Access Compliance Report

Public Rights-of-Way

(Curb Ramps)

Intersection ID: 42957	Main Street: PHEASANT_GLEN_RD	Cross Street: SPARROW_SPRINGS_LN	Location: NW
ADA ID: B838C2AA0174	Ramp Type: PerpDiag	Initial Pass/Fail: Fail	Overall Compliance: No
Severity Score: 33.75			
Codes/Mitigation Info/Possible Solution		Field Measurements/Component Compliance

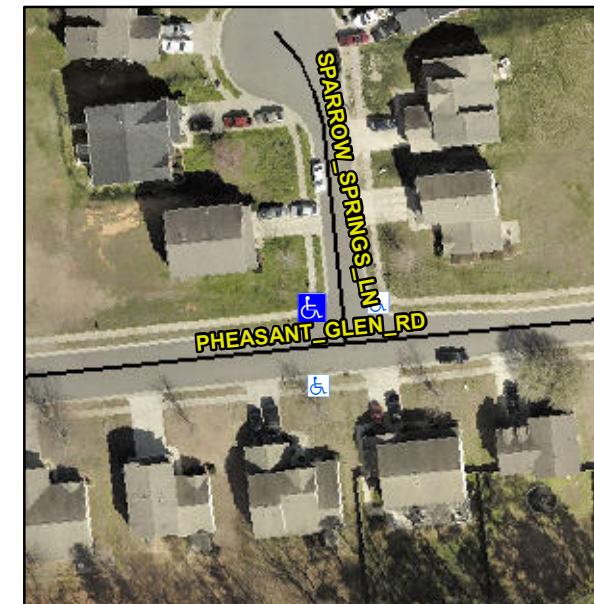
Not Found, R304.5.1, R304.5.3

Compliance	Description	Data	Compliance	Description	Data
N/A	Ramp Length (in)	44.0	Yes	Ramp Slope (%)	6.3
No	Ramp Width (in)	45.5	No	Ramp XSlope (%)	10.1
N/A	Flare Type LT	N/A	N/A	Flare Type RT	N/A
N/A	Flare Slope LT (%)	N/A	N/A	Flare Slope RT (%)	N/A
N/A	Flare Traversable LT?	N/A	N/A	Flare Traversable RT?	N/A
N/A	Landing Length (in)	N/A	N/A	DWS Provided?	N/A
N/A	Landing Width (in)	N/A	N/A	DWS Contrast?	N/A
N/A	Landing Slope (%)	N/A	N/A	DWS Length (in)	N/A
N/A	Landing X Slope (%)	N/A	N/A	DWS Full Width?	N/A
N/A	Landing Curb? (Y/N)	N/A	N/A	DWS Offset (in)	N/A
N/A	Shared Landing?	N/A			
N/A	Gutter Ponding?	N/A	N/A	Gutter Slope (%)	N/A
N/A	Gutter Lip Ht (in)	N/A	N/A	Gutter X Slope (%)	N/A
N/A	Painted X Walk1?	No	N/A	Painted X Walk2?	No
	X Walk 1 Direction	To S		X Walk 2 Direction	To E
N/A	X Walk 1 Width (in)	N/A	N/A	X Walk 2 Width (in)	N/A
	X Walk 1 Slope (%)	4.9		X Walk 2 Slope (%)	5.3
	X Walk 1 X Slope (%)	5.1		X Walk 2 X Slope (%)	8.5

Remove & Replace Curb Ramp With Two New Directional Ramps or Equivalent.
